Odell's House Mitigation Project

Johnston County, North Carolina

Re: NCIRT Review and USACE Approval of the NCDMS Odell's House Mitigation Site / Johnston Co./ SAW-2018-00431/ NCDMS Project # 100041

RE: RE: WLS Responses to NCIRT 30-day Review Comments Regarding Task 3 Submittal, Final Mitigation Plan Approval for Odell's House Mitigation Project, USACE AID# SAW-2018-00431, NCDEQ DMS Full-Delivery Project ID #100041, Contract #7420, Neuse River Basin, Cataloging Unit 03020201, Johnston County, NC

Figure 10 – Proposed Monitoring Features Map

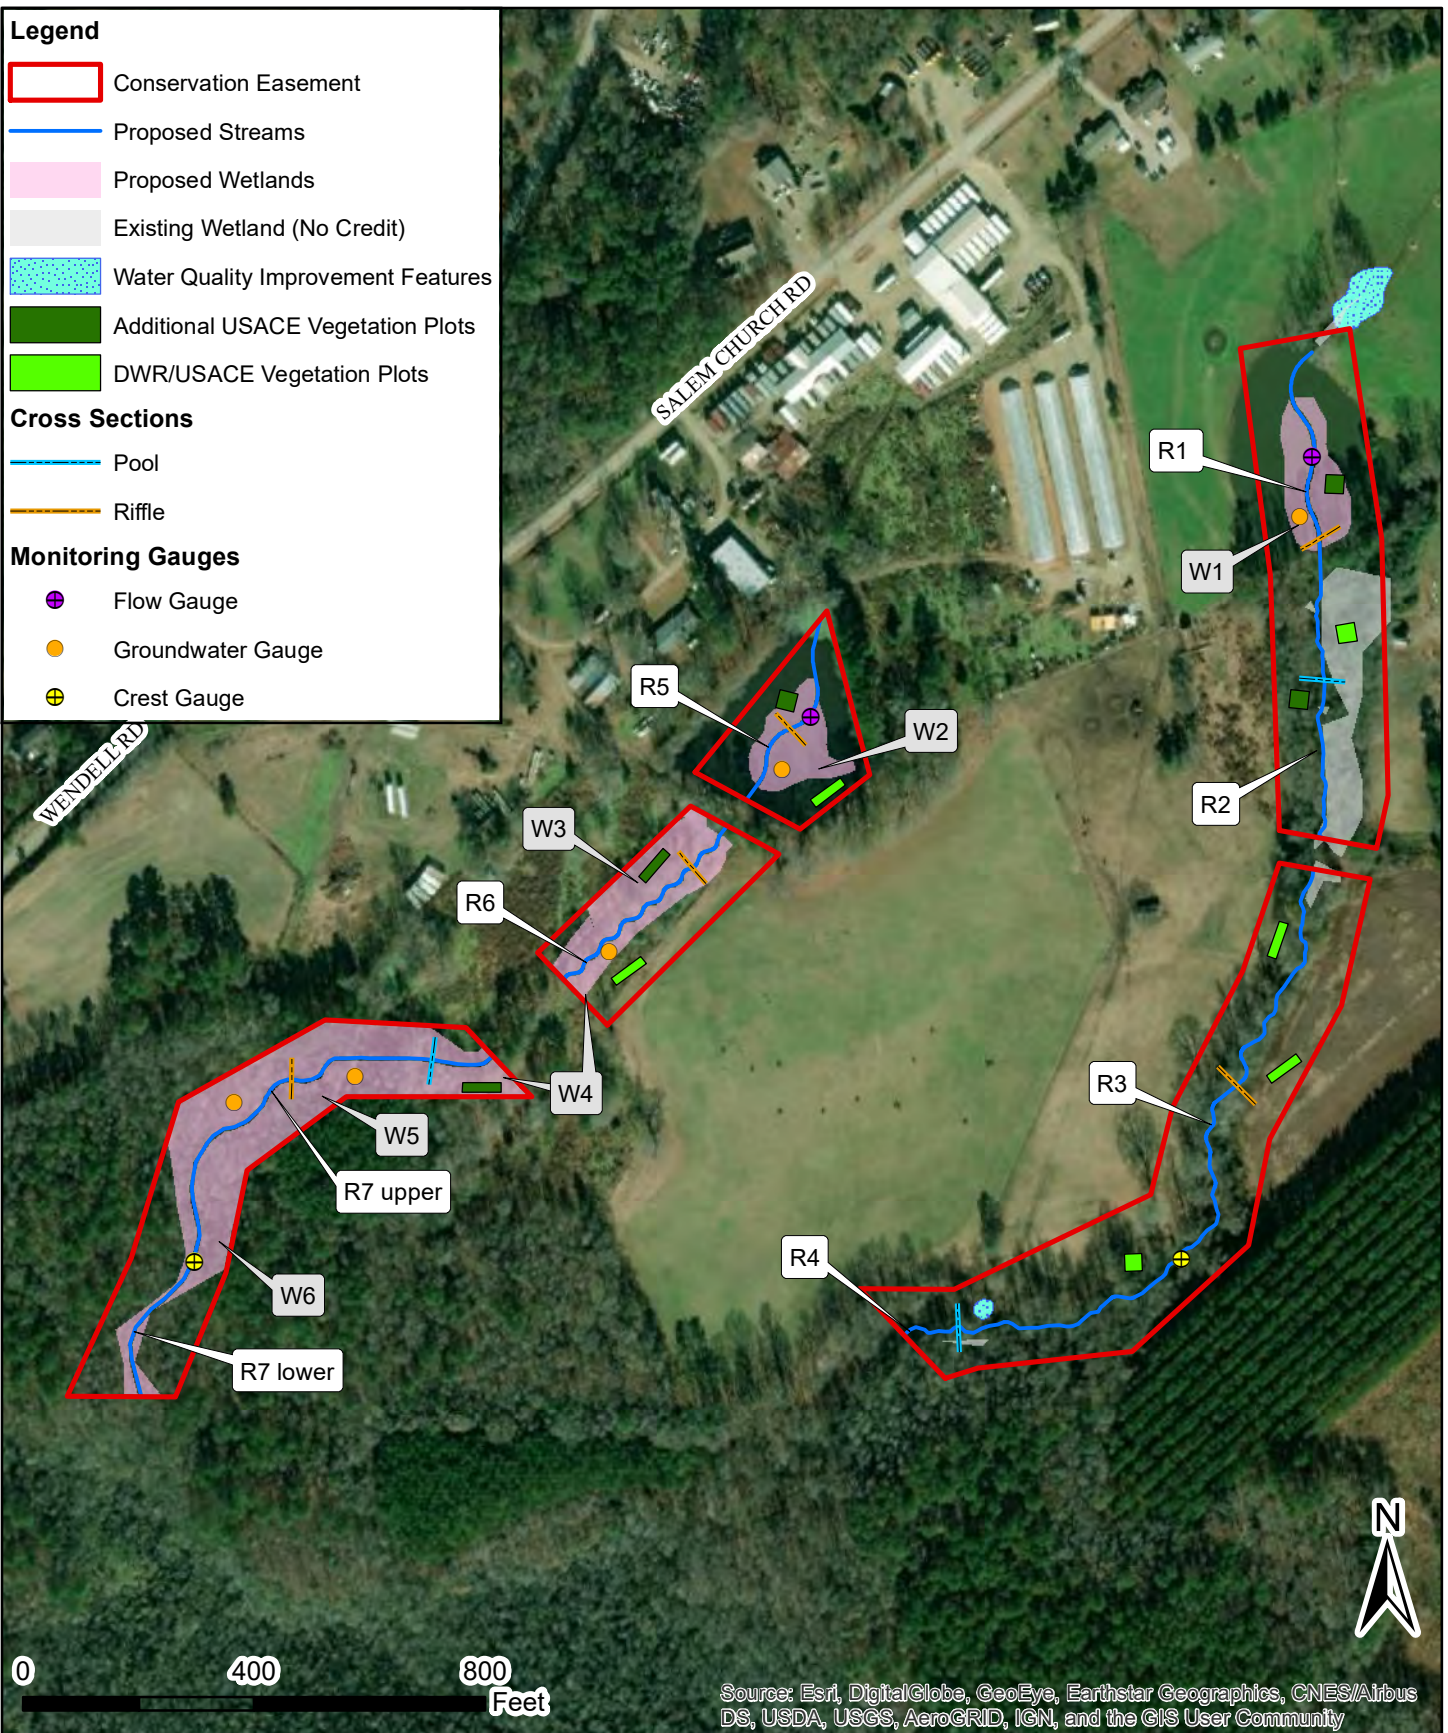
- 18. Figure 10 –**
- a. DWR requests the wetland gauge along R6 be shifted to the reestablishment area and an additional wetland gauge be installed in W5, south of R7 Upper, to demonstrate hydrologic enhancement.** Response: WLS has shifted the gauge to the re-establishment area as well as adding an additional gauge in W5, seen on figure 10.

- b. DWR requests an additional cross section in the middle segment of R7 Upper.**
Response: The additional cross section has been added.
 - c. Please show locations of proposed crest gauge/pressure transducers for Bankfull measurements as described in Section 8.2.1.** Response: The location of the crest gauges/pressure transducers are now shown on figure 10.

- e. Please show existing onsite non-credit wetland areas.** Response: The non-credit wetland areas have been added to figure 10.
- 19. Sheet 6 – DWR appreciates all of the information presented in the Channel Block detail.**

13

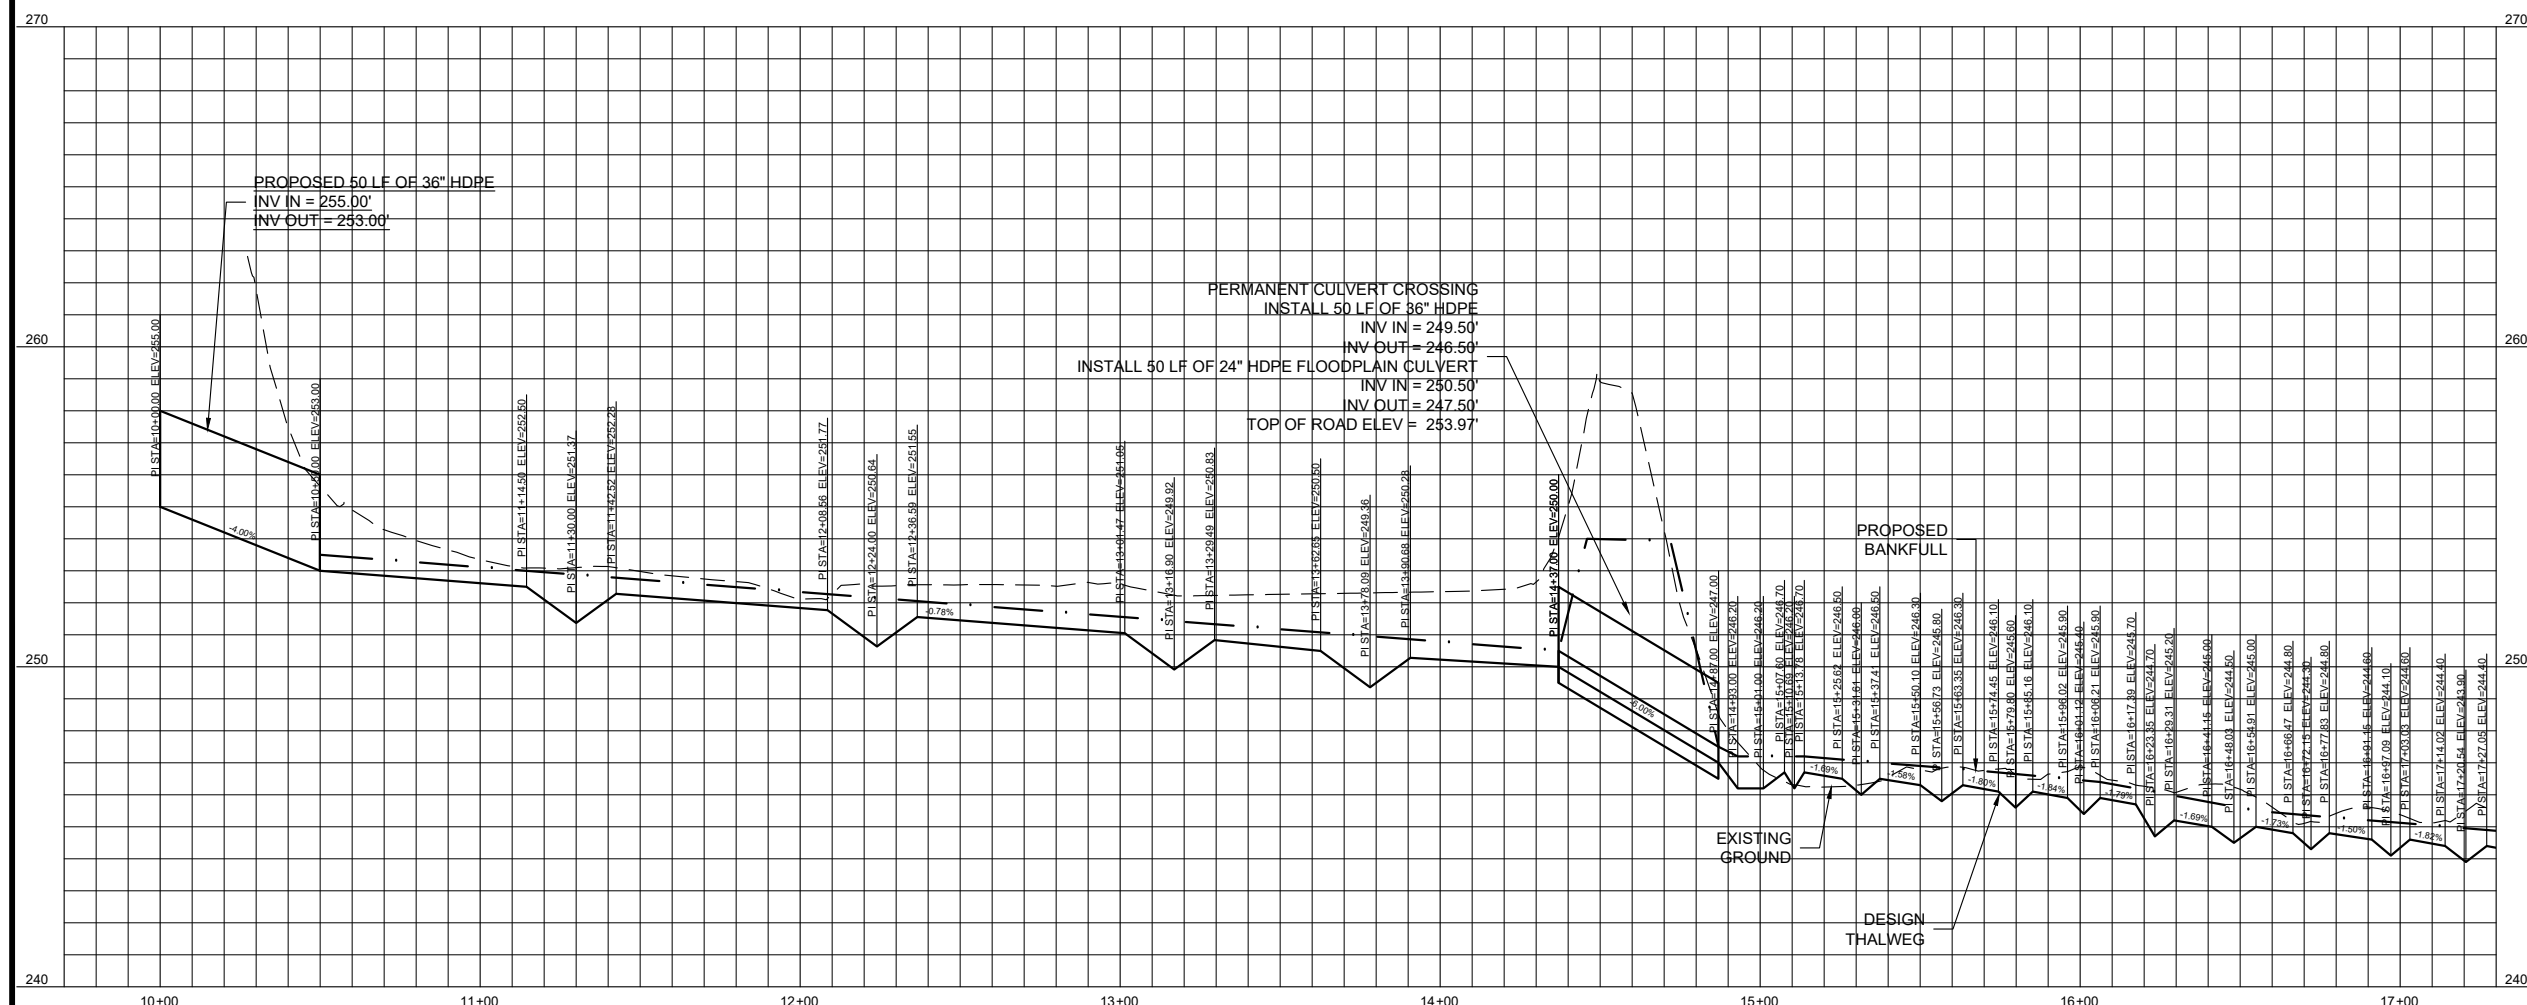
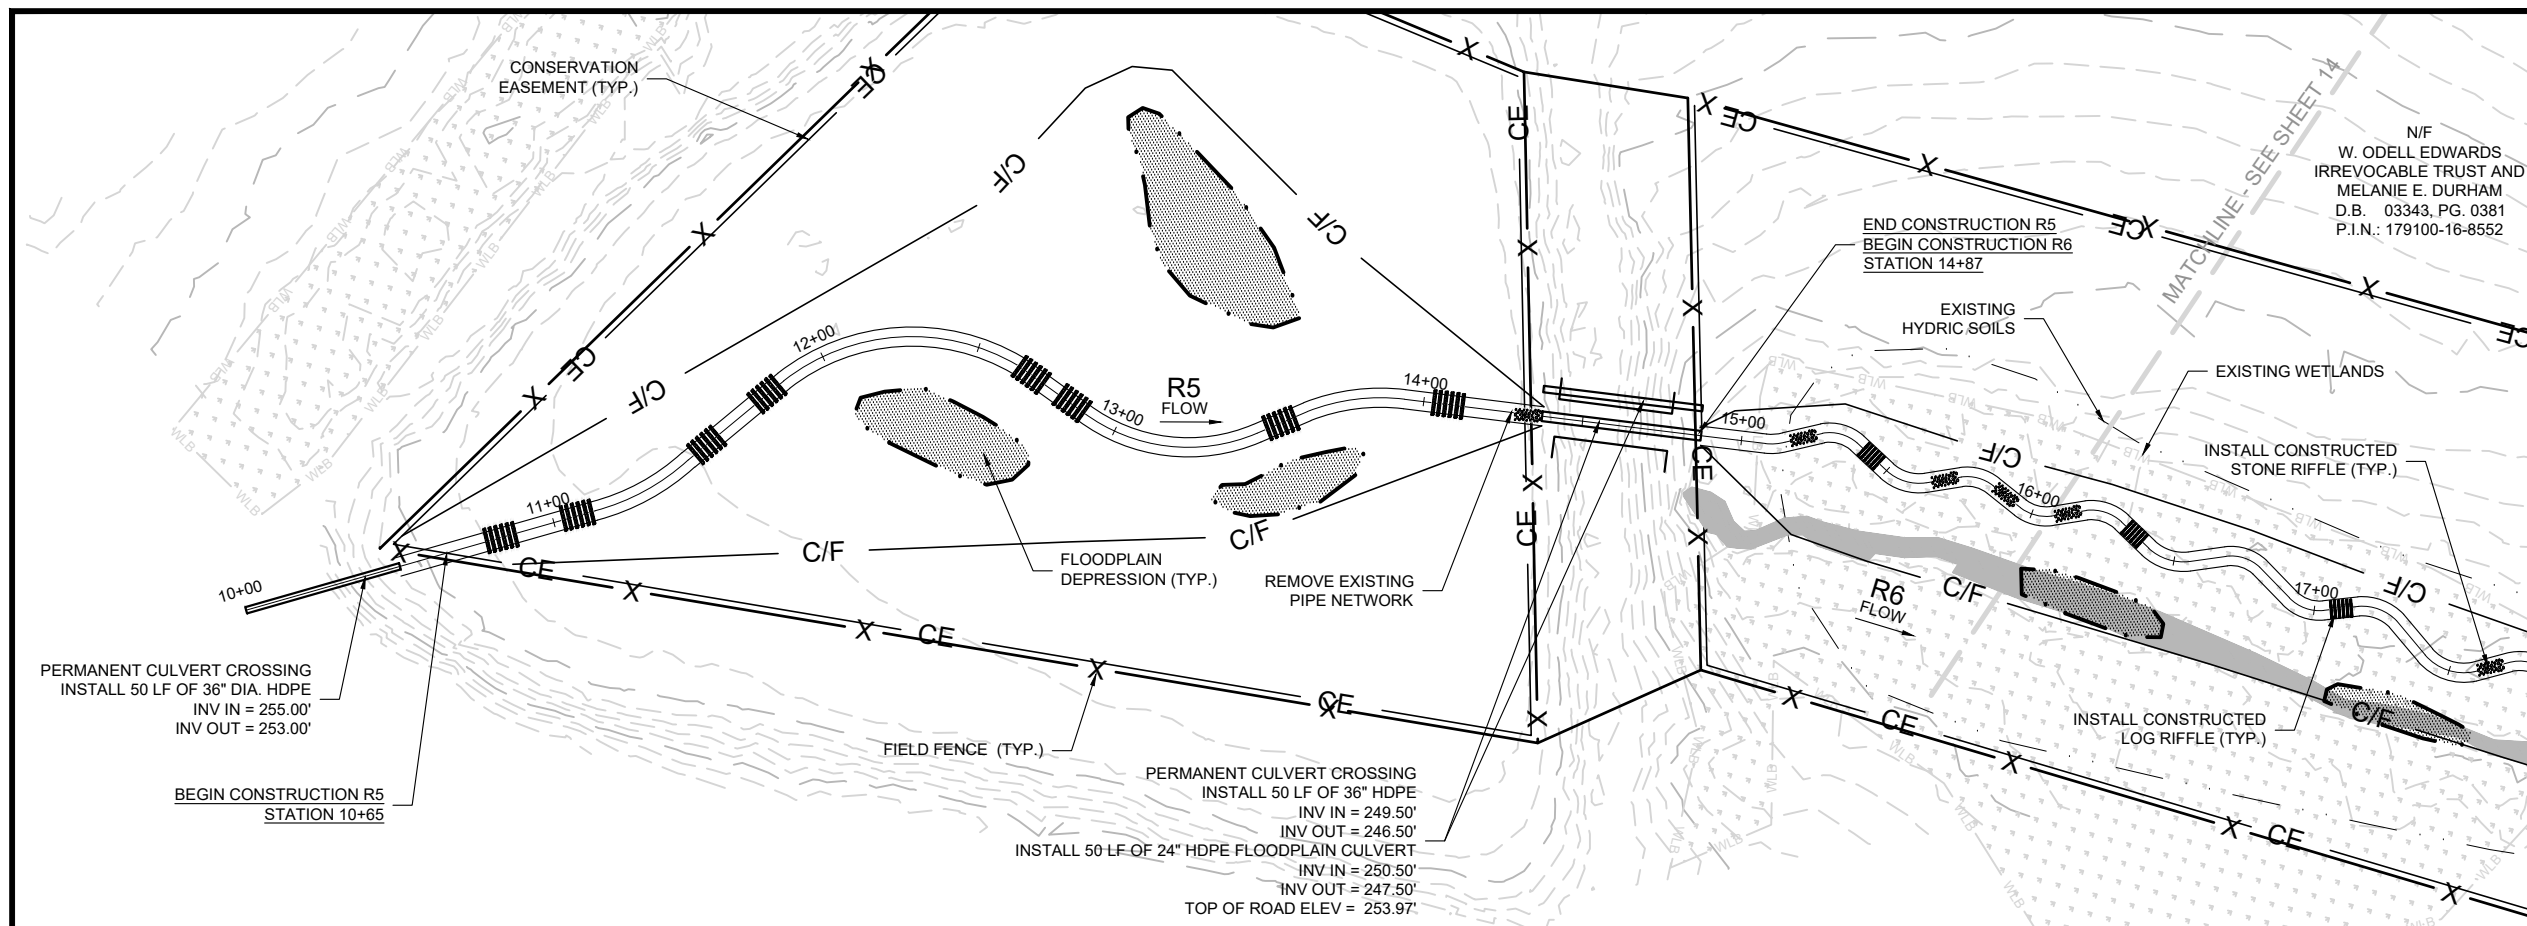
Response: WLS will continue to use the channel block detail.
- 20. Sheet 13 – Can the plan view please be shifted to show the extent of the cut/fill limits of the pond.** Response: WLS has adjust the view to include the cut/fill limits.

FIGURE
6A

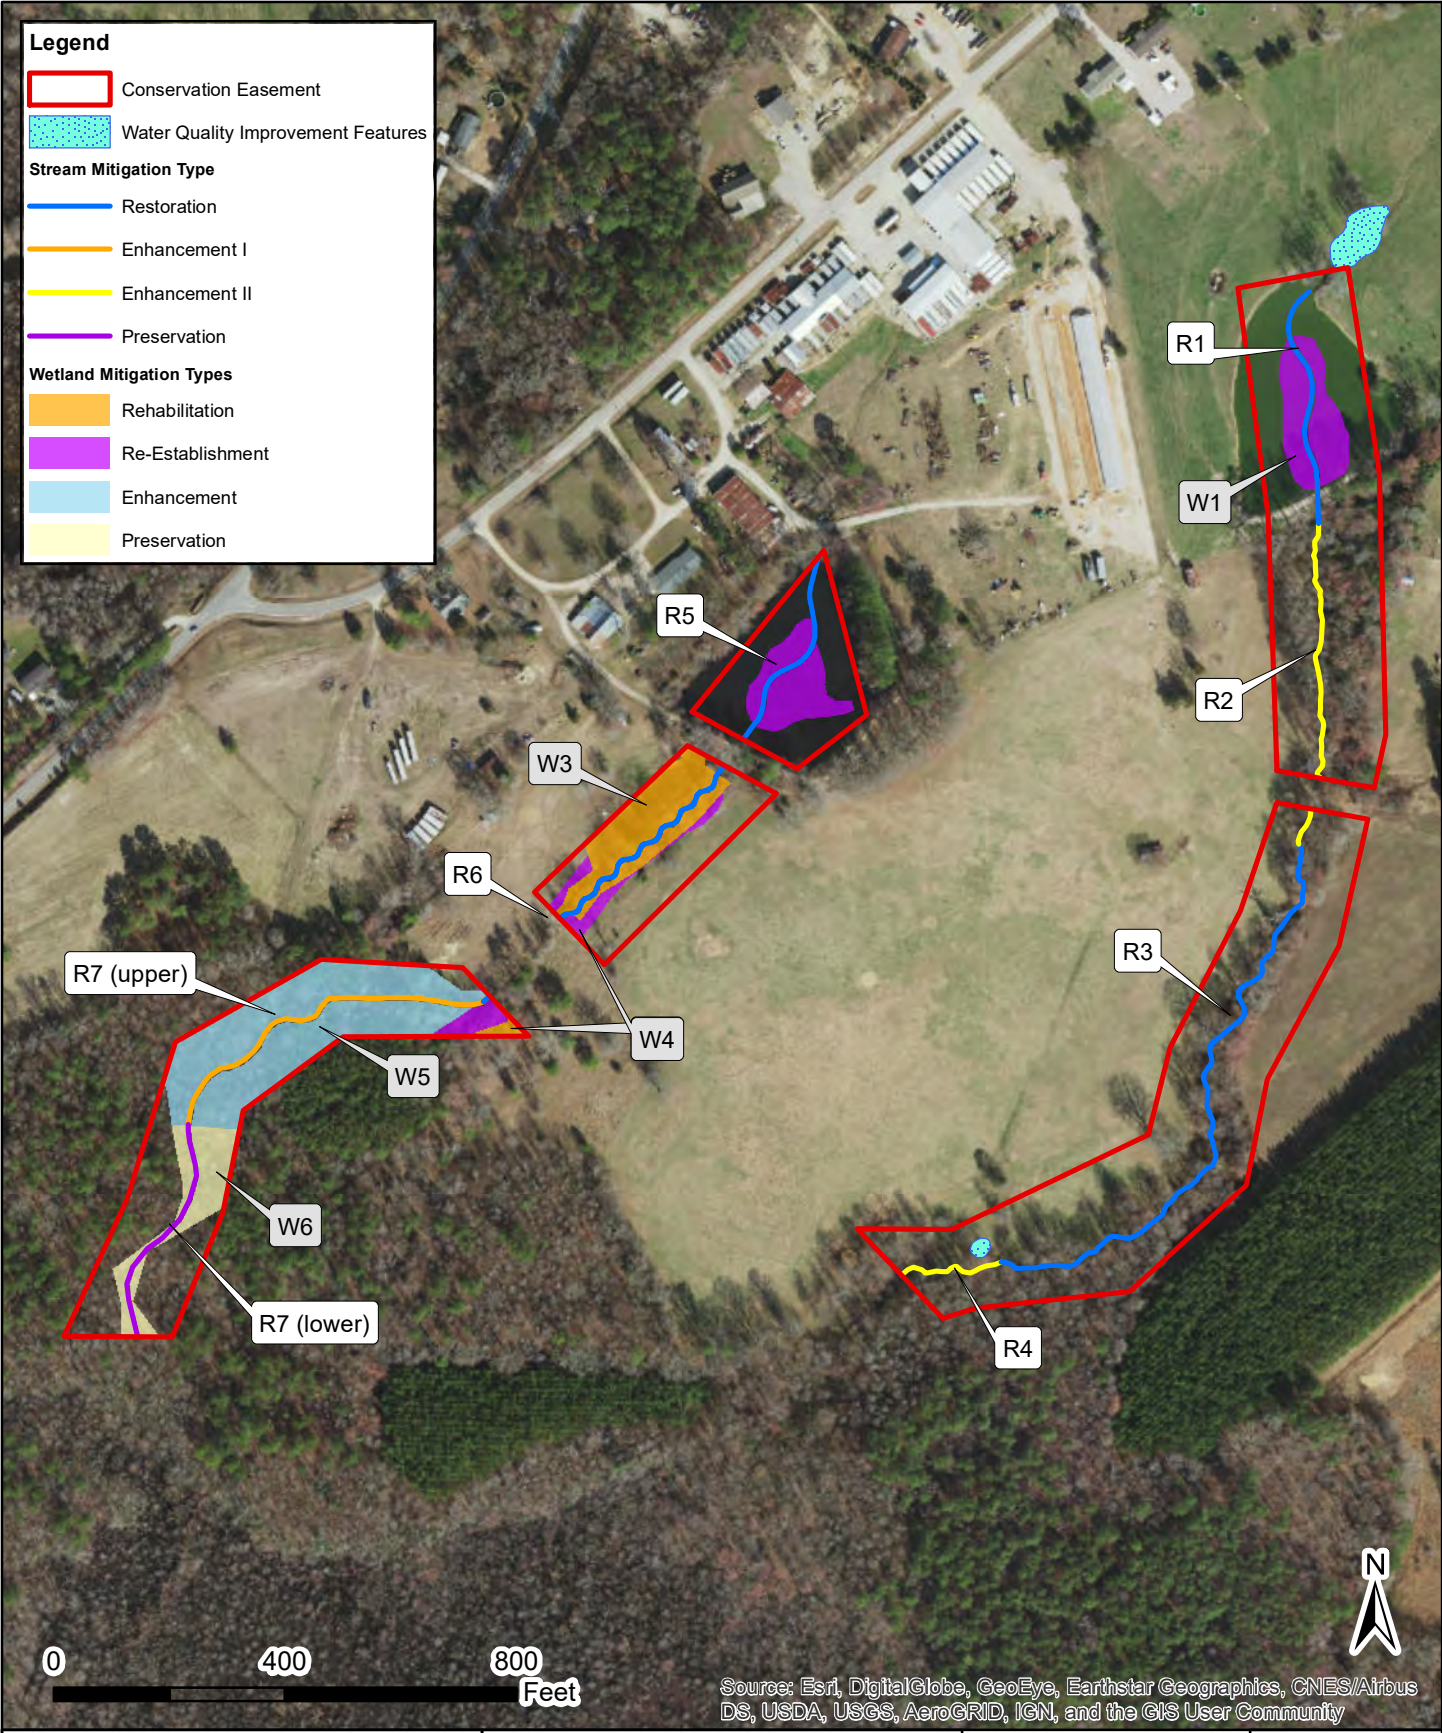
**34. If expecting to have the flexibility to convert to nutrient offset as indicated by this table, please add text below the table that speaks to that. If DMS wants to have the flexibility of these credits, DWR needs to see a Nutrient Offset Concept Map added to the figures showing where Nutrient Offset credit is viable. Make sure to exclude the Cattle & Bamboo areas and Coastal HW areas, as well as any areas less than 50'.
Response: DMS would like to have the flexibility to convert to nutrient offset credit and a note has been added below the table. Figure 6A has been added to show the areas where nutrient offset credit is viable the map is titled Nutrient Offset Concept Map.**
